# SR 125/SR 32 FOCUS AREA ADVISORY COMMITTEE MEETING NOTES

## MEETING #3 NOTES

August 20, 2018

**Figure X-1D**  
 WESTBOUND THROUGH LANE EXTENDING  
 TO WOOSTER ROAD

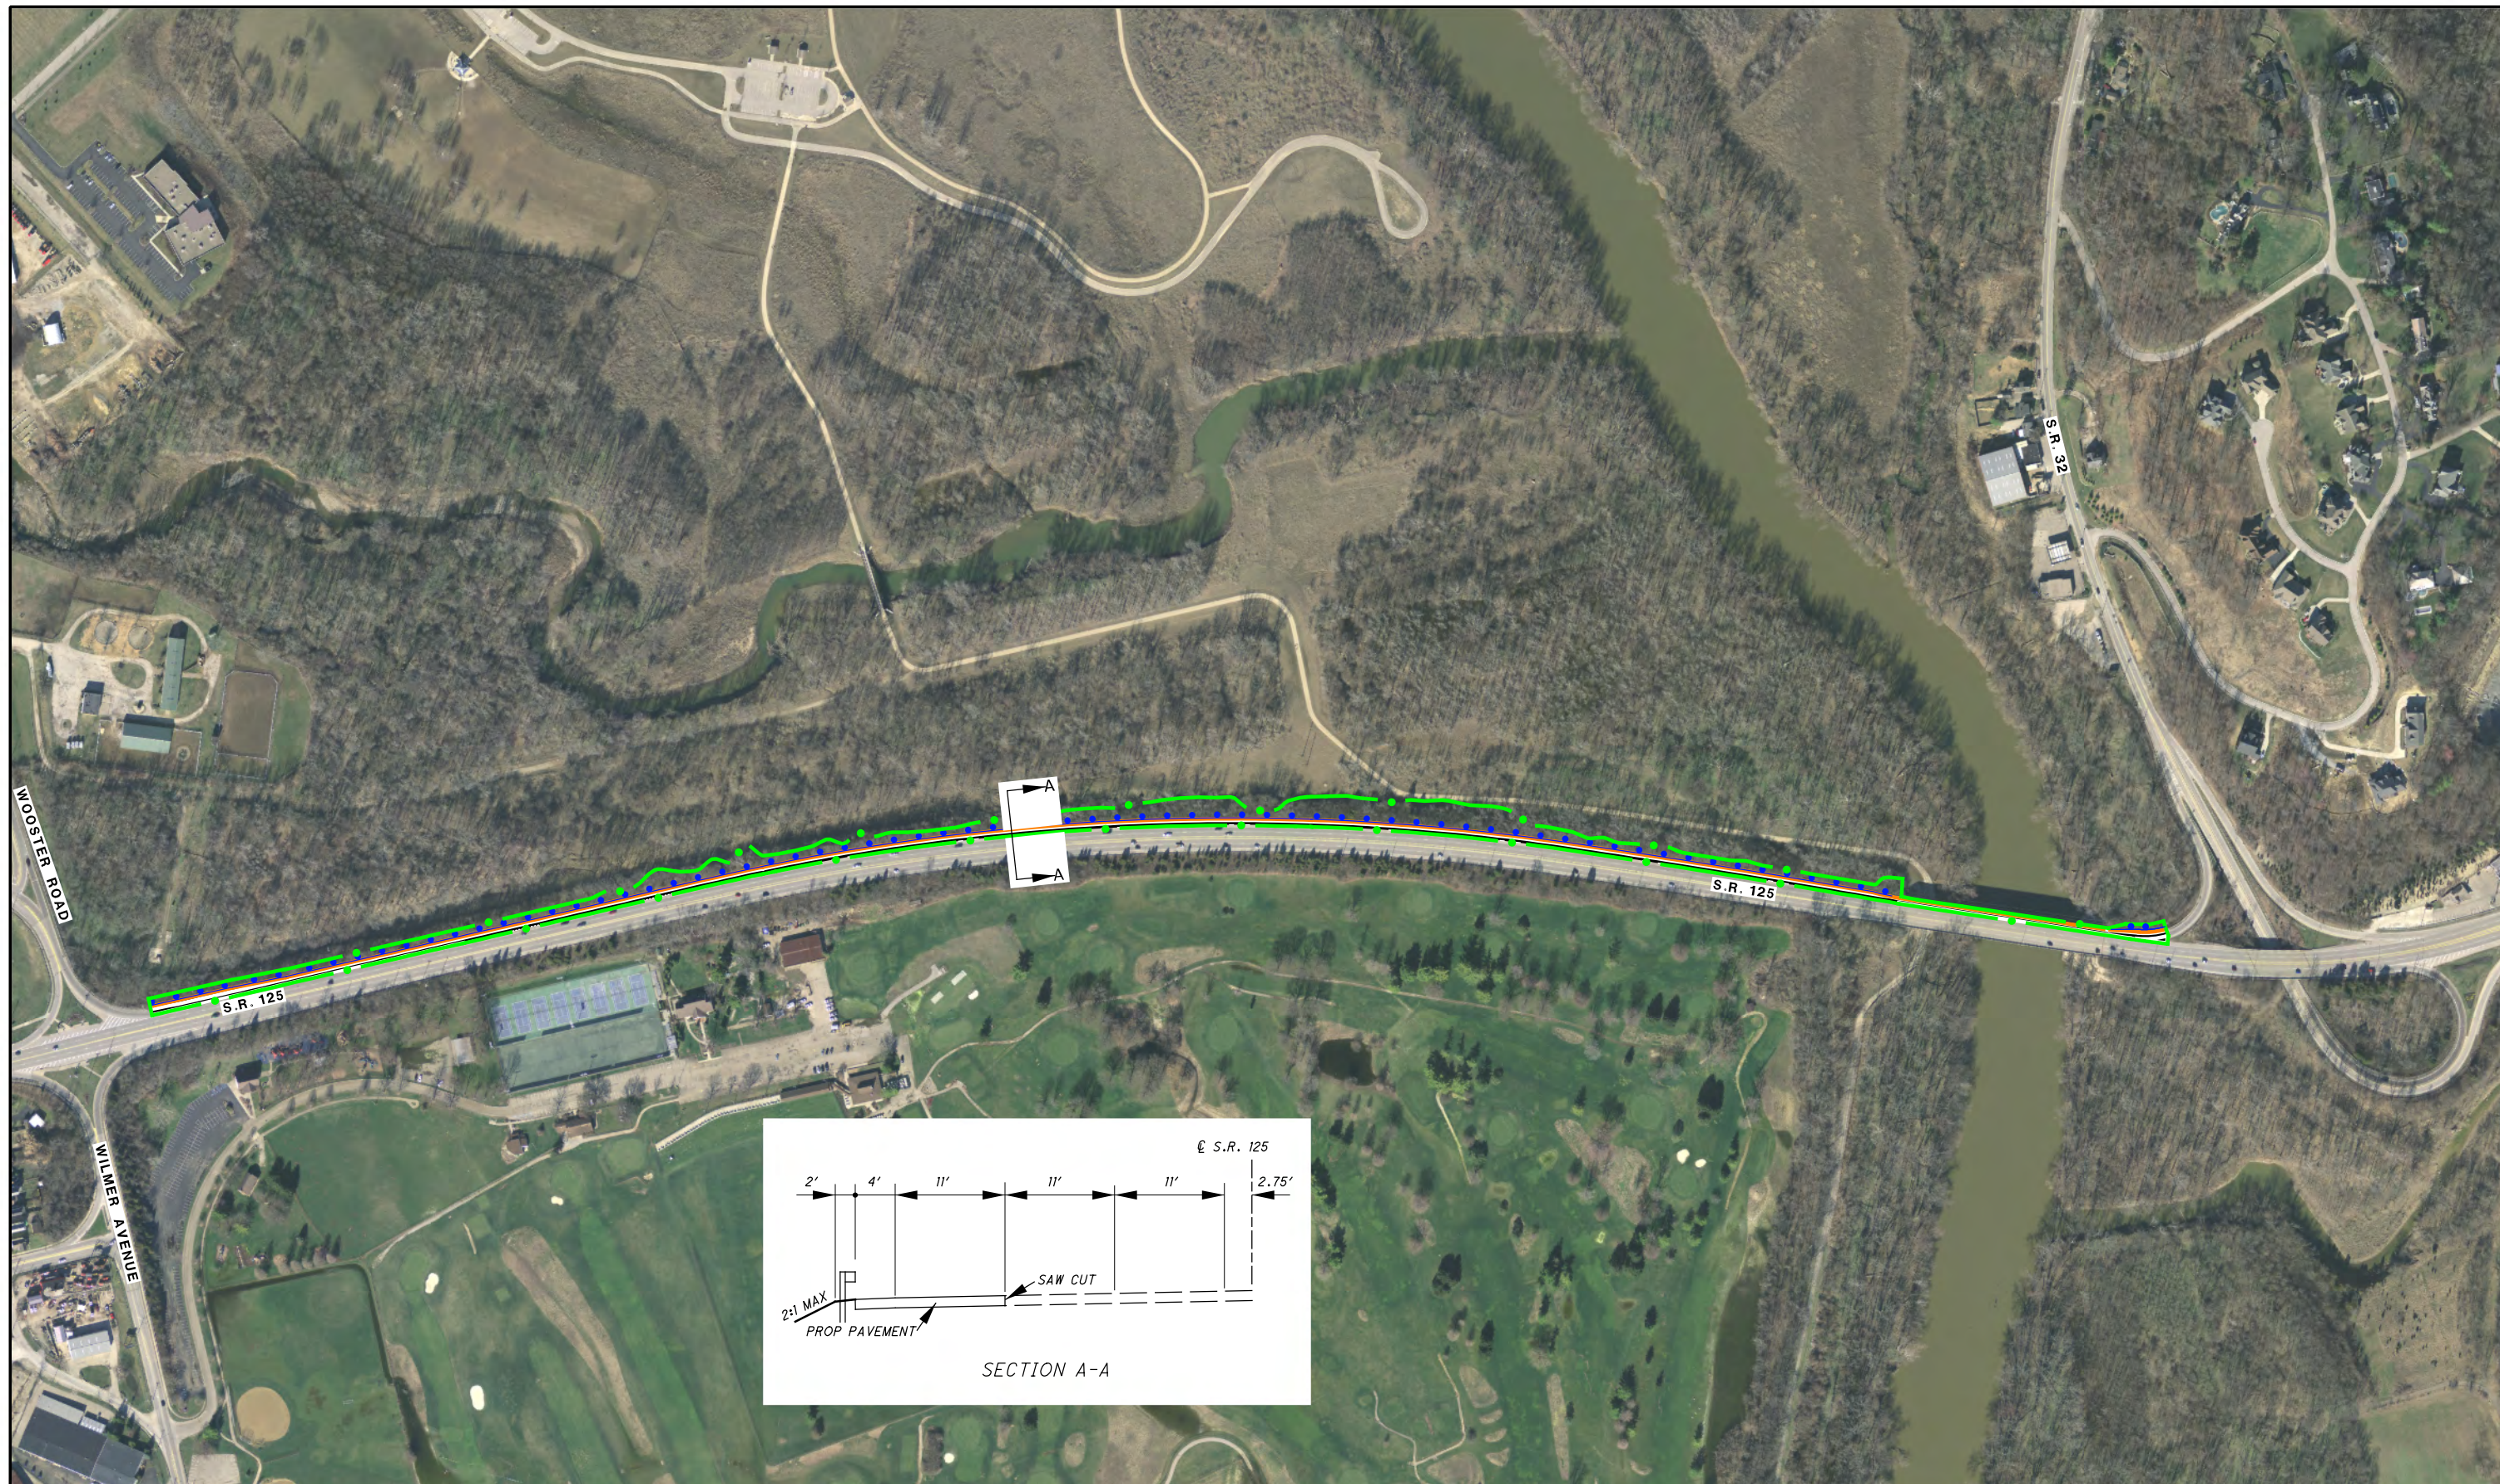
- (continued)
- Committee members felt that the current merging pattern isn't too problematic and establishing a wider road might encourage faster travel speeds. But, pedestrian and bicyclist needs still must be met.
  - Traffic modeling shows that three lanes are not needed; two work sufficiently.
- Comments Submitted Following the 8/20 Meeting  
(Comments are presented as submitted by Committee members; no edits to content were made.)
- To be added as comments are received.

- The additional westbound lane would extend between the SR 125 and SR 32 interchange and the intersections of SR 125 and Wilmer and Wooster.
- Some widening of SR 125 would be needed to maintain four-foot shoulders (reducing the width of the shoulders could be a concern when cars break down).

- No further study. Traffic modeling shows that there is no need for an additional westbound lane.

**Figure 32-1A**  
**CROSSING FROM TURPIN LAKE PLACE  
 AND ROPES DRIVE TO THE LITTLE MIAMI TRAIL**

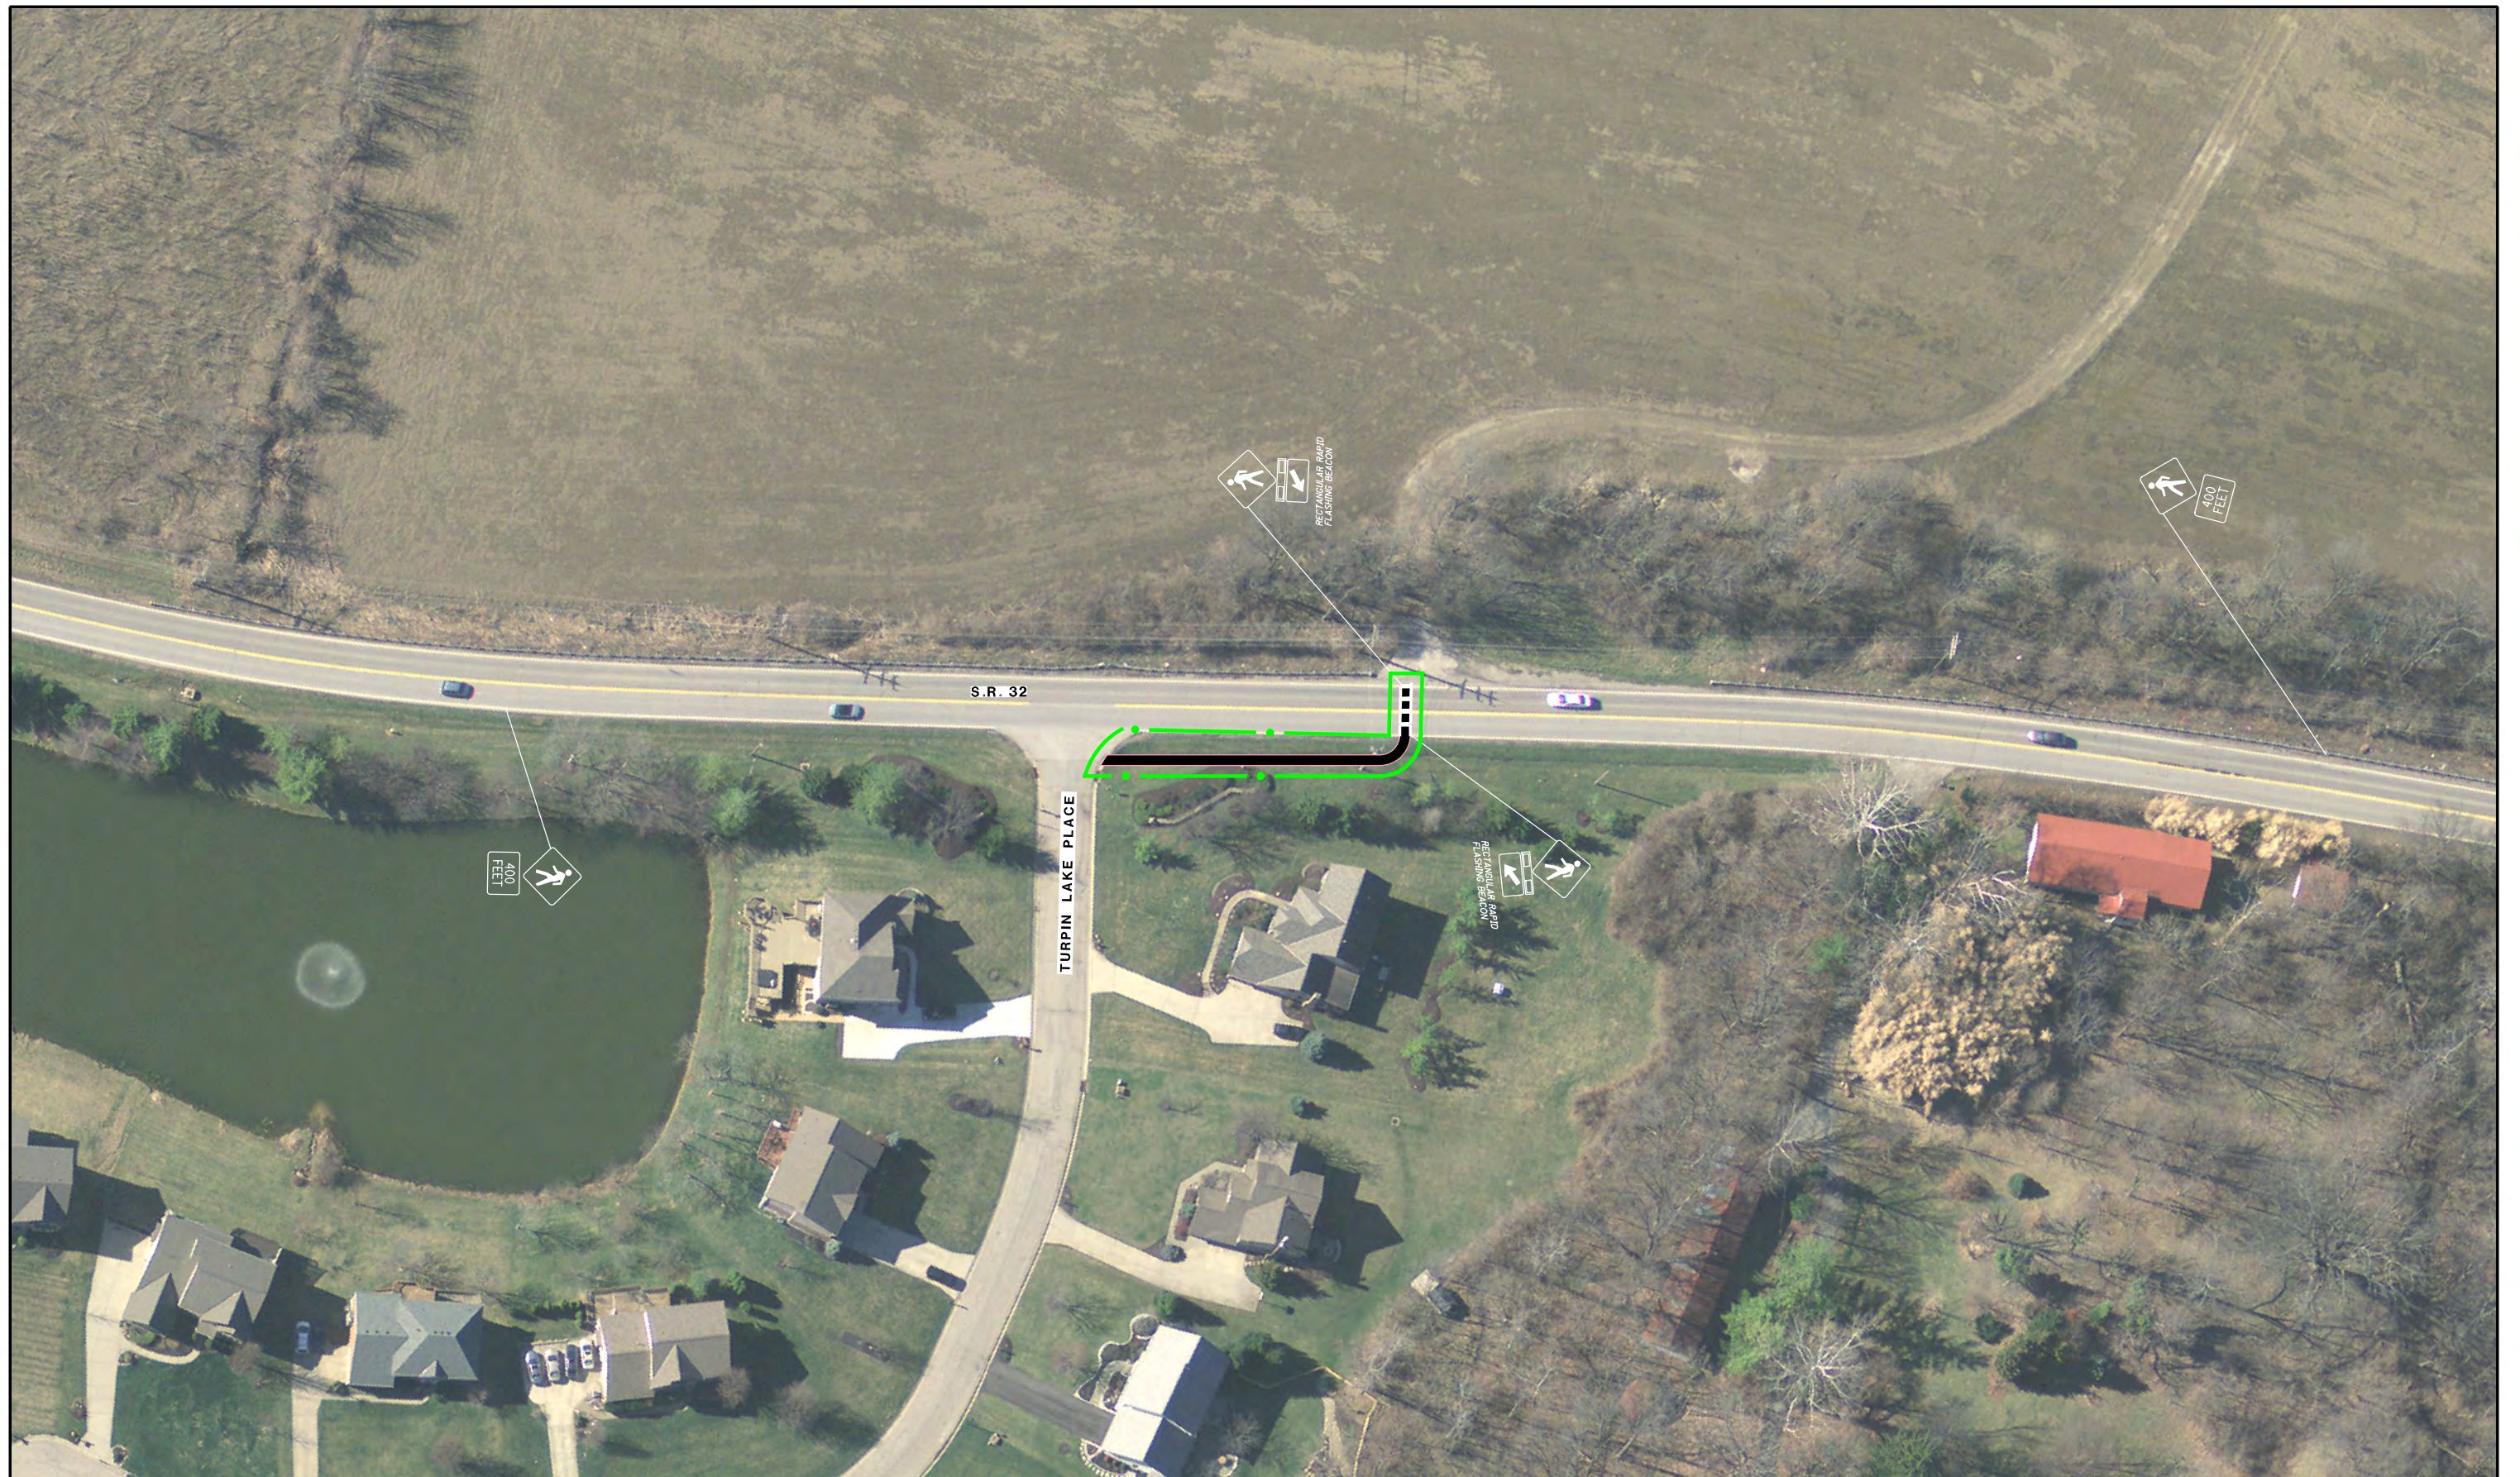
- ODOT/Stantec currently think that the proposed path is within the right-of-way (ROW) for the road. If it isn't, acquiring the necessary ROW could add to the cost (less than \$10K) and potentially add one more year to the construction process.
